# Access Compliance Report

## Public Rights-of-Way

Intersection ID: 20410	Main Street: CARMEL_RD	Cross Street: FAIRVIEW_RD	Location: NW
ADA ID: 35B523DB49AF	Ramp Type: Perp	Initial Pass/Fail: Fail	Overall Compliance: No
Severity Score: 12.5			
Codes/Mitigation Info/Possible Solution		Field Measurements/Component Compliance

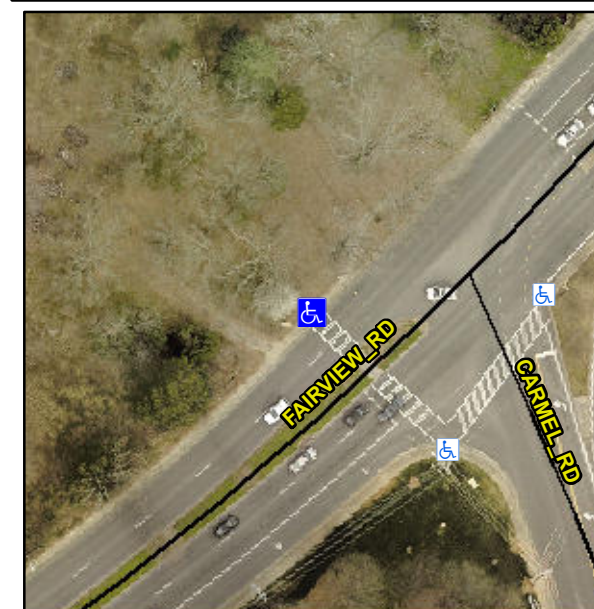
**Not Found, R304.2.2**

Compliance	Description	Data	Compliance	Description	Data
N/A	Ramp Length (in)	60.0	No	Ramp Slope (%)	8.8
Yes	Ramp Width (in)	48.0	Yes	Ramp XSlope (%)	1.4
N/A	Flare Type LT	N/A	N/A	Flare Type RT	N/A
N/A	Flare Slope LT (%)	N/A	N/A	Flare Slope RT (%)	N/A
N/A	Flare Traversable LT?	N/A	N/A	Flare Traversable RT?	N/A
N/A	Landing Length (in)	N/A	N/A	DWS Provided?	N/A
N/A	Landing Width (in)	N/A	N/A	DWS Contrast?	N/A
N/A	Landing Slope (%)	N/A	N/A	DWS Length (in)	N/A
N/A	Landing X Slope (%)	N/A	N/A	DWS Full Width?	N/A
N/A	Landing Curb? (Y/N)	N/A	N/A	DWS Offset (in)	N/A
N/A	Shared Landing?	N/A			
N/A	Gutter Ponding?	N/A	N/A	Gutter Slope (%)	N/A
N/A	Gutter Lip Ht (in)	N/A	N/A	Gutter X Slope (%)	N/A
N/A	Painted X Walk1?	Yes	N/A	Painted X Walk2?	N/A
	X Walk 1 Direction	To SE		X Walk 2 Direction	N/A
N/A	X Walk 1 Width (in)	126.0	N/A	X Walk 2 Width (in)	N/A
	X Walk 1 Slope (%)	2.6		X Walk 2 Slope (%)	N/A
	X Walk 1 X Slope (%)	0.7		X Walk 2 X Slope (%)	N/A

**Remove & Replace Entire Ramp.**
